INVITATION TO BID
BID NO. 9934
TROY SCHOOL DISTRICT 2022 PAVING PROGRAM

This Addendum is issued as modifications to the RFP previously issued to provide clarifications to the scope of work. This Addendum supersedes the original RFP. This along with the RFP becomes the bid documents.

1. For questions e-mail purchasingoffice@troy.k12.mi.us or through Buildingconnected.com.
2. Addendum #1 dated January 18, 2022 as prepared by PEA Group. (Attached)
3. Revise Bid Package, Proposal Form. Revise PF-2. Add Alternate #2 for Facilities and Operations Building. (Attached)
4. Pre-Bid Meeting Sign In Sheet dated January 18, 2022. (Attached)

DRAWING NUMBER:
C-2.0

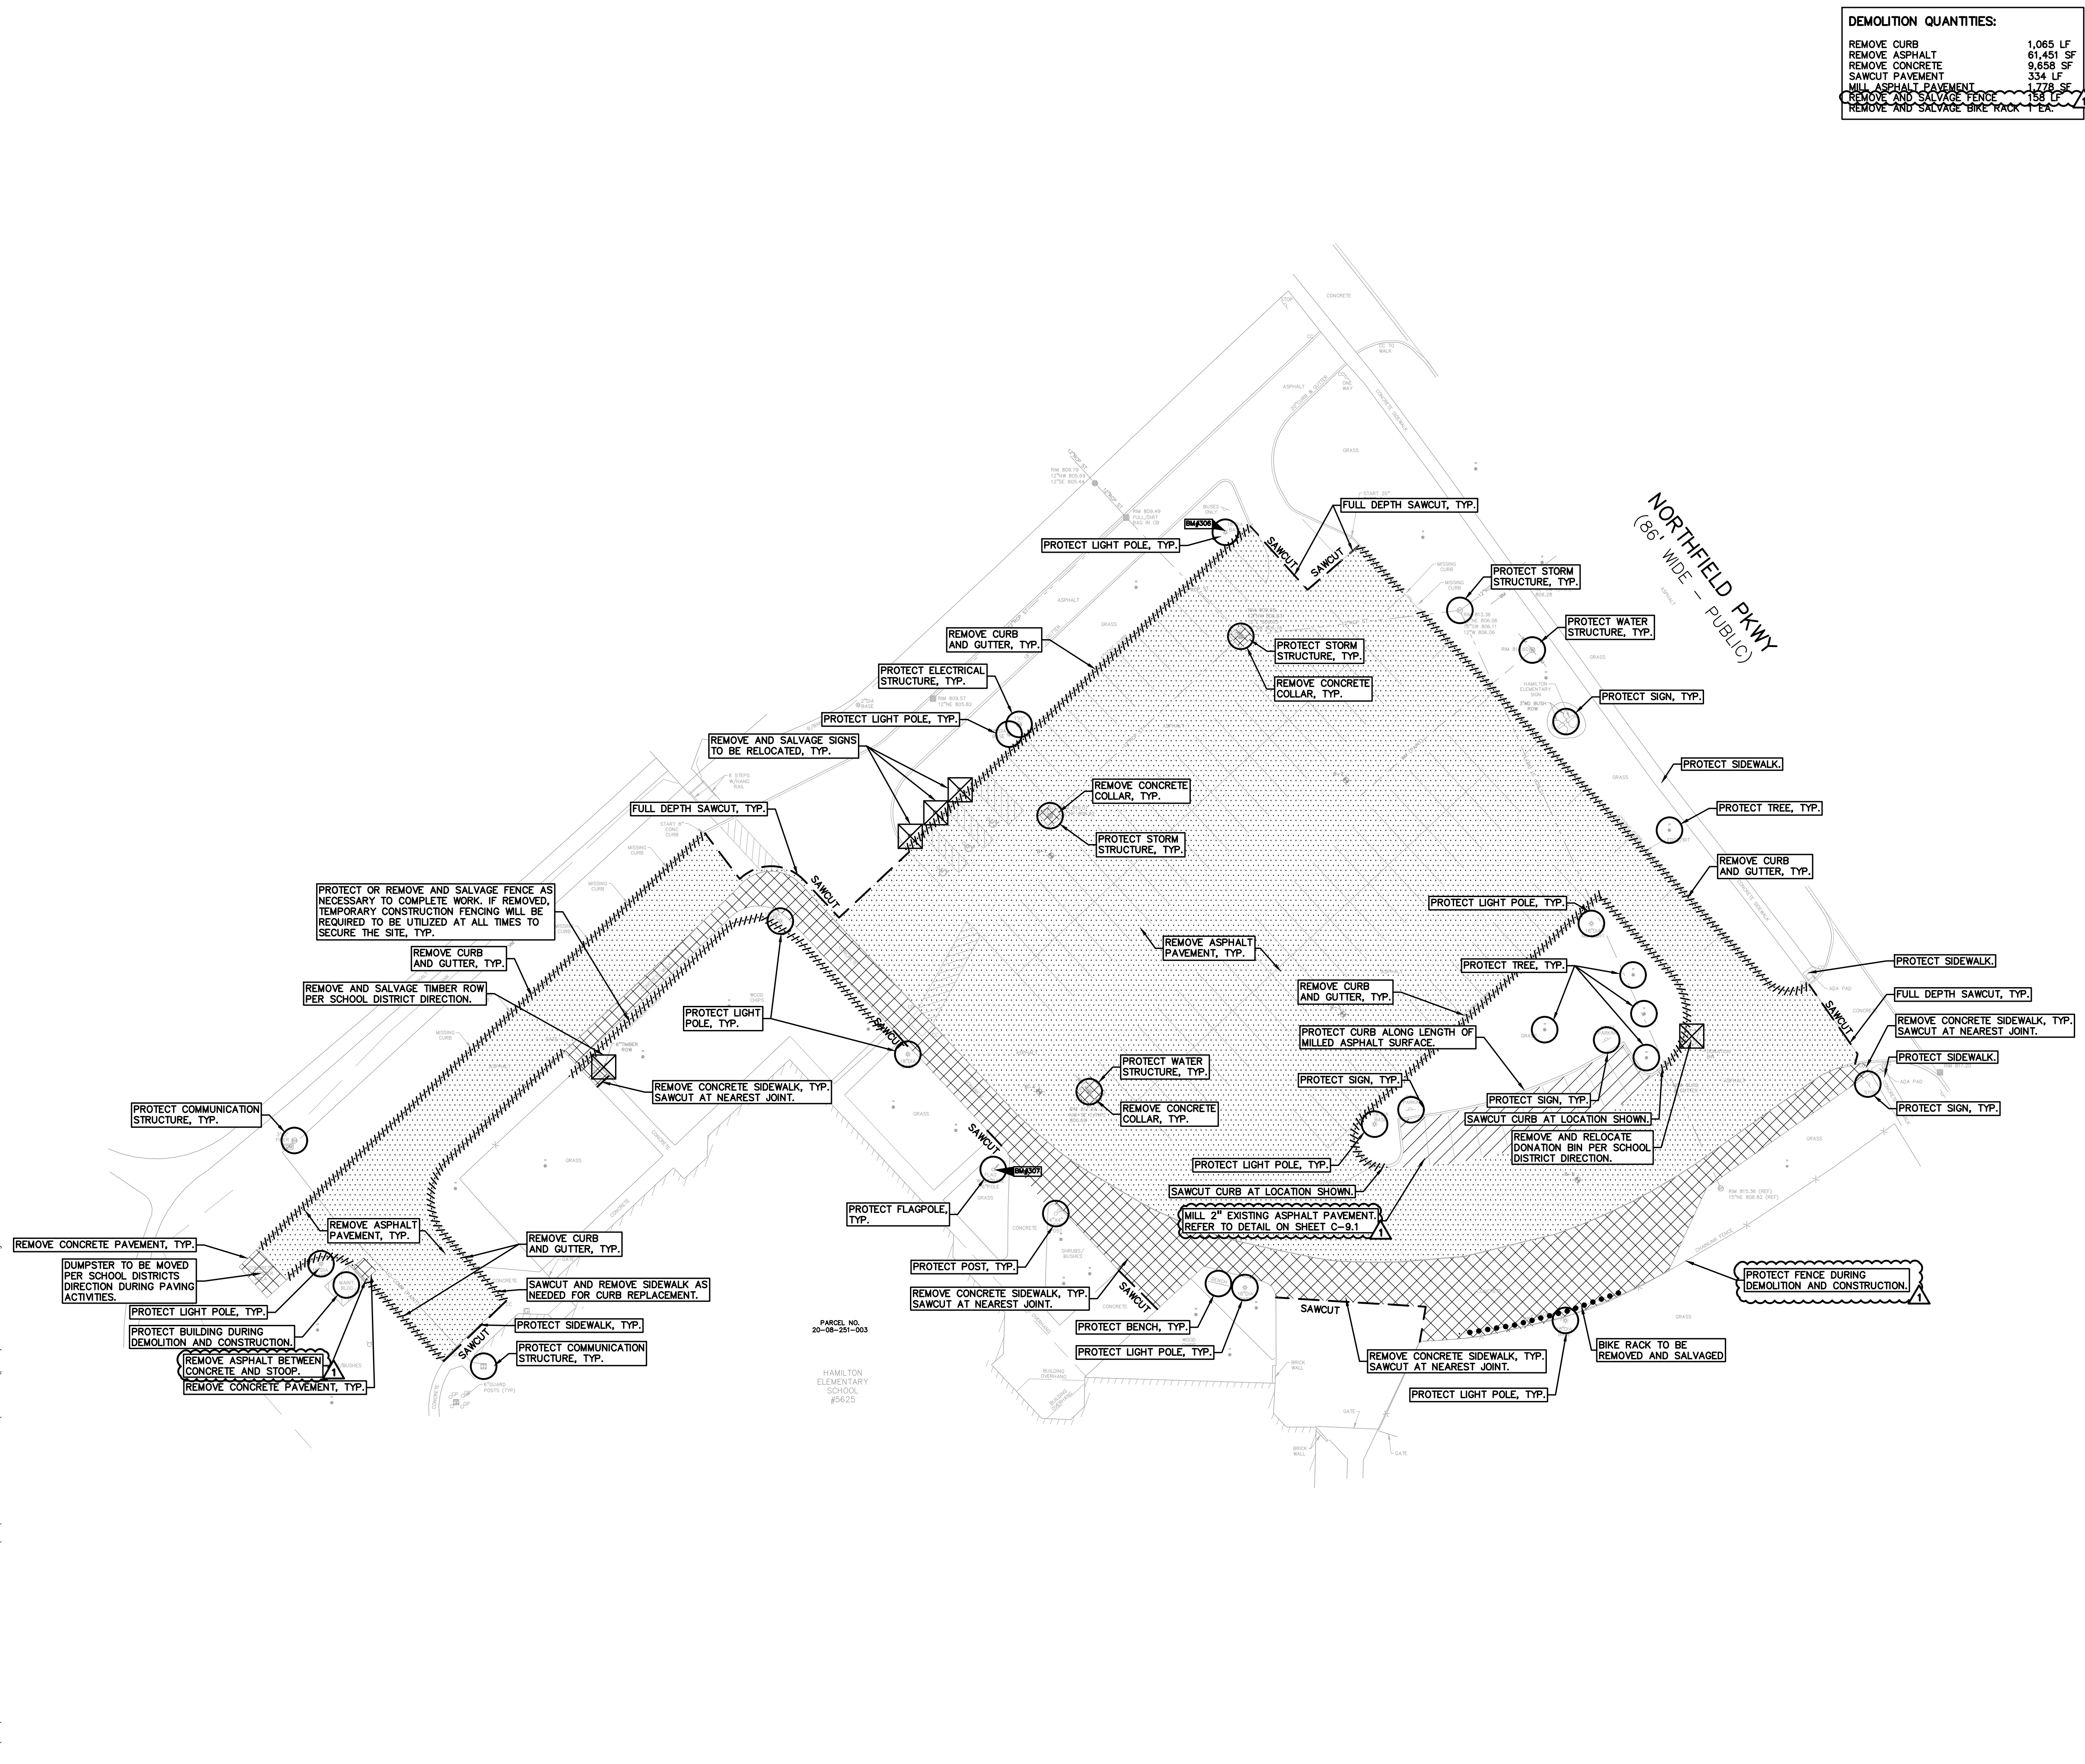
2. Hamilton Elementary:
 - a. Sheet C-2.0
 1. A note has been added to remove the asphalt between the concrete ramp and stoop for the shed.
 2. The thickness for the mill area was revised to 2” to match the detail and wearing course thickness of the propose pavement.

NOT FOR CONSTRUCTION **C-2.1**

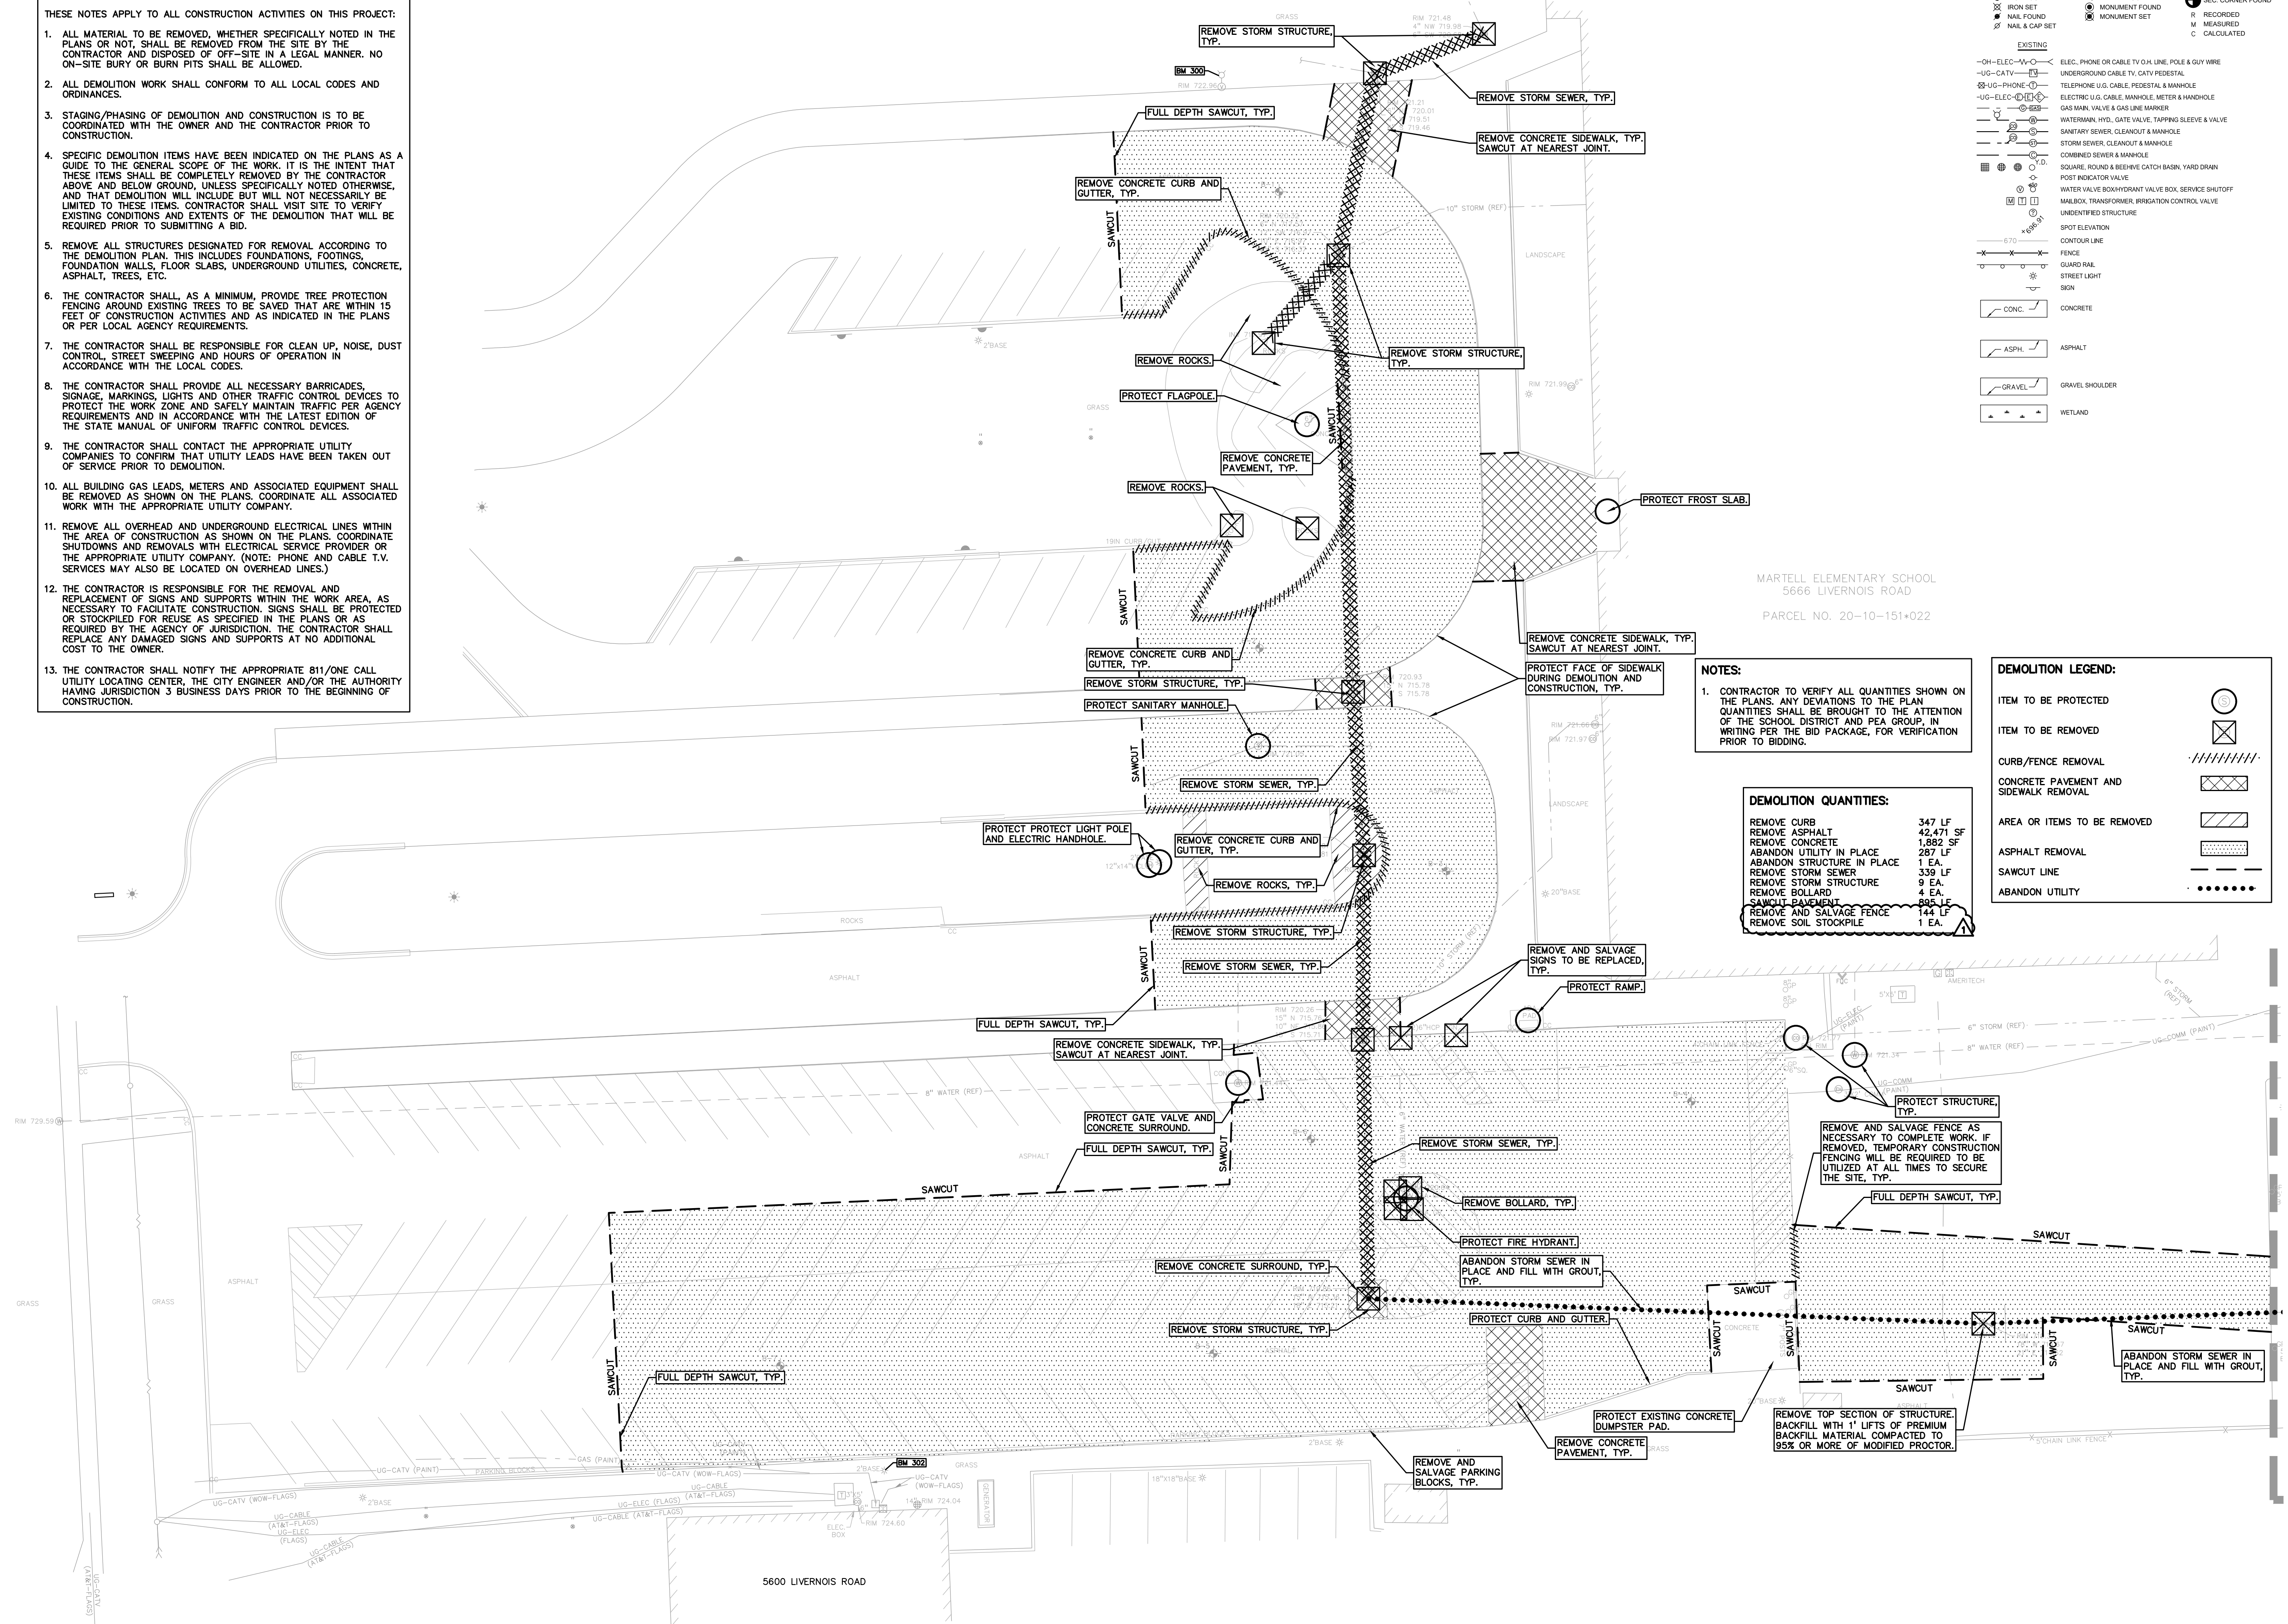
3. Martell Elementary:
 - a. Sheet C-2.1
 1. The rocks called out to be removed are to be disposed of per the plans and specifications. They will not be salvaged and reused.

C-2.2

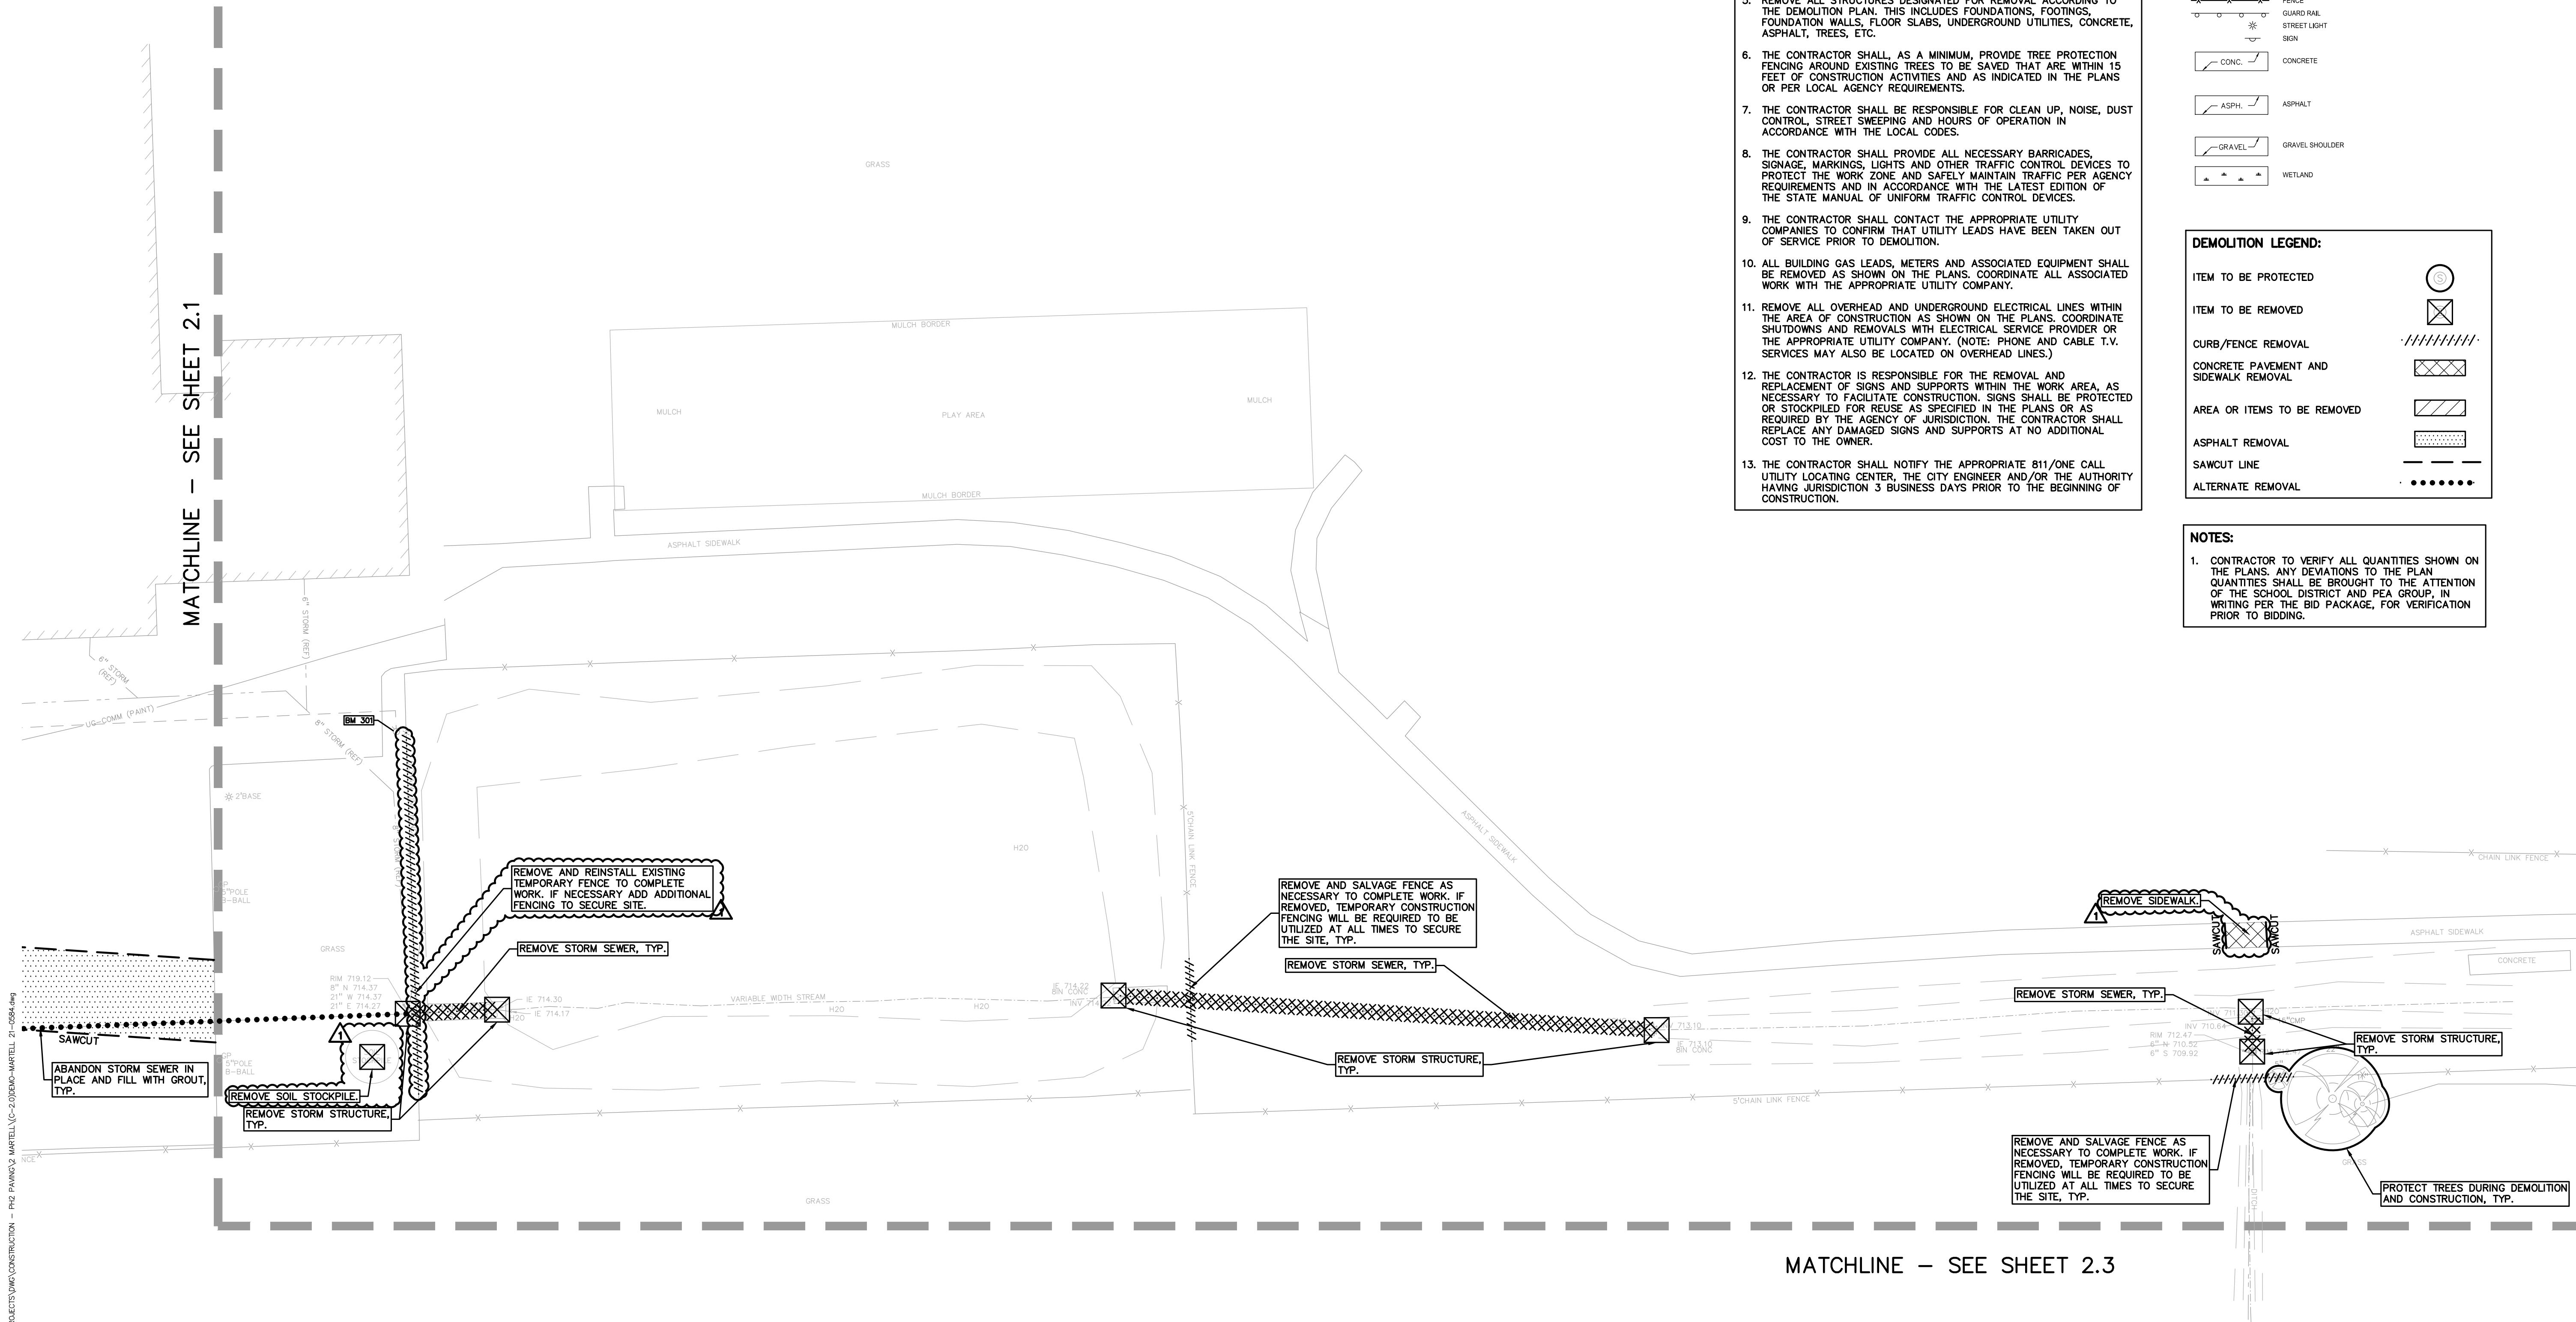
- b. Sheet C-2.2
 - 1. The call out has been updated to reflect that there is temporary construction fencing, and not chain link mesh, along the west side of the pond. The contractor is to utilize the existing temporary construction fencing and add to it as needed, to secure the area during completion of this project. Therefore, there will not be any fencing removal along the west side of the pond. If any existing poles need to be removed to complete the work it is expected that they be reinstalled upon completion of the work at no additional costs to the district.

- 2. The contractor is responsible to remove any sections of fencing that has to be removed in order to complete the scope of work for this project in all other areas of the site, other than the west side of the pond, as shown on the plans.
